Project	IEEE 802.16 Broadband Wireless Access Working Group < http://ieee802.org/16 >	
Title	Efficient and Secure Security Framework in PKMv2	
Data Submitted	2005-03-17	
Source(s)	Seokheon Cho, Sungcheol Chang, Chulsik Yoon, ETRI Sanjay Bakshi, Yigal Eliaspur, Intel Corporation Junhyuk Song, Jicheol Lee, Yong Chang Samsung	Voice: +82-42-860-5524 Fax: +82-42-861-1966 chosh@etri.re.kr sanjay.bakshi@intel.com junhyuk.song@samsung.com
Re:	IEEE P802.16e/D6	
Abstract	The existing PKMv2 is somewhat unorganized and insecure security framework. This contribution provides a resolution for unorganized and insecure issues in the PKMv2.	
Purpose	Adoption of proposed changes into P802.16e/D6	
Notice	This document has been prepared to assist IEEE 802.16. It is offered as a basis for discussion and is not binding on the contributing individual(s) or organization(s). The material in this document is subject to change in form and content after further study. The contributor(s) reserve(s) the right to add, amend or withdraw material contained herein.

Efficient and Secure Security Framework in PKMv2

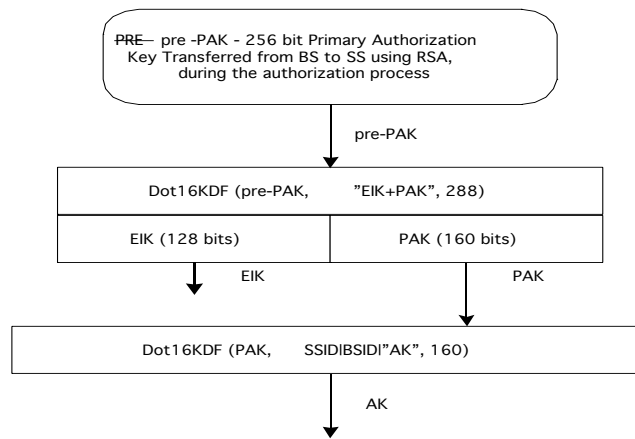
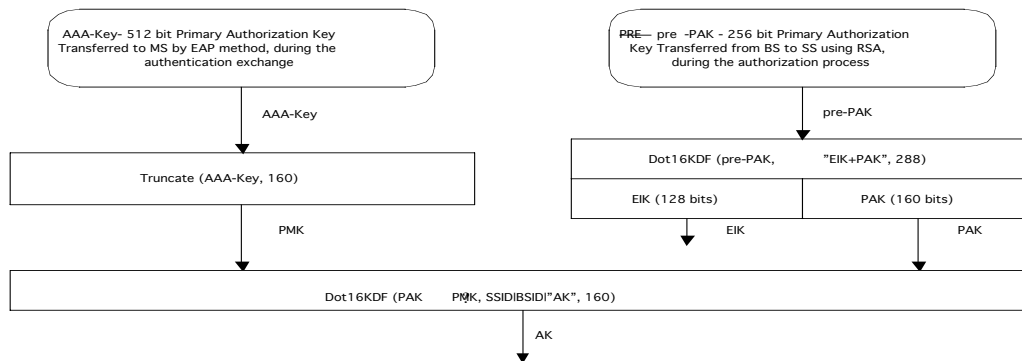
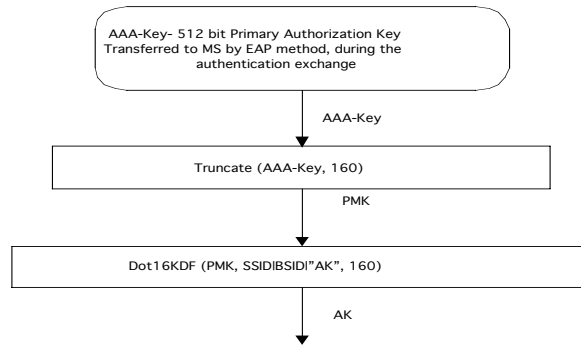
- The AK is derived from PAK or/and PMK which are generated and distributed from the BS and Authenticator, respectively.
- The input key used for AK generation is the PMK. The PAK should be also used to generate the AK as not input data but an input key.

- a) The input key for generating the AK should be both PMK and/or PAK. The exclusive-or (XOR: \oplus) value of PAK and PMK as input key is used to generate the AK. The generation method of the AK is as follows.

If (RSA-based authorization and EAP-based authorization)
 $AK \Leftarrow \text{Dot16KDF}(\text{PAK} \oplus \text{PMK}, \text{SSID}|\text{BSID}|"AK", 160)$
 Else if (RSA-based authorization)
 $AK \Leftarrow \text{Dot16KDF}(\text{PAK}, \text{SSID}|\text{BSID}|"AK", 160)$
 Else if (EAP-based authorization)
 $AK \Leftarrow \text{Dot16KDF}(\text{PMK}, \text{SSID}|\text{BSID}|"AK", 160)$

Figure 131-AK with the only RSA-based only authorization process

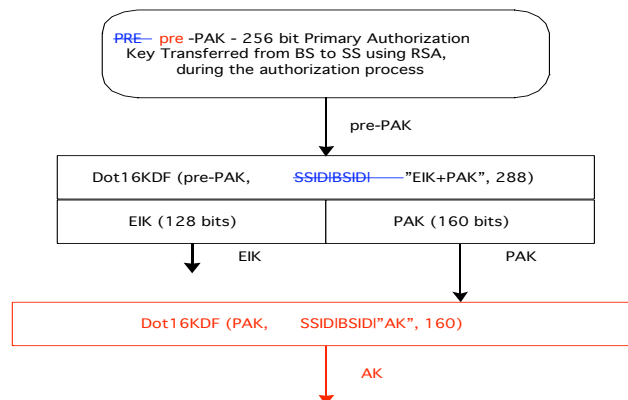
Figure 131 outlines the process to calculate the AK when the RSA-based authorization process has taken place, but where the EAP-based authentication process hasn't taken place, or the EAP method used has not yielded an AAA-key:

Figure 132-AK with RSA and EAP authorization process

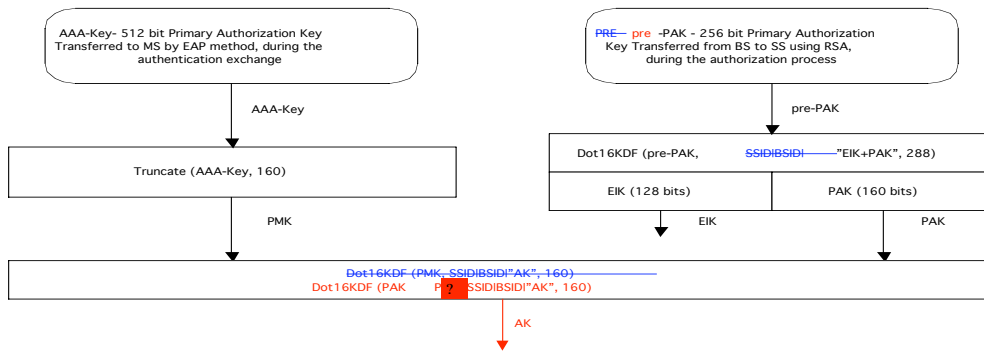
Figure 132 outlines the process to calculate the AK when both the RSA-based authorization exchange has taken place, yielding a PAK and the EAP based authentication exchange has taken place, yielding an AAA-key:
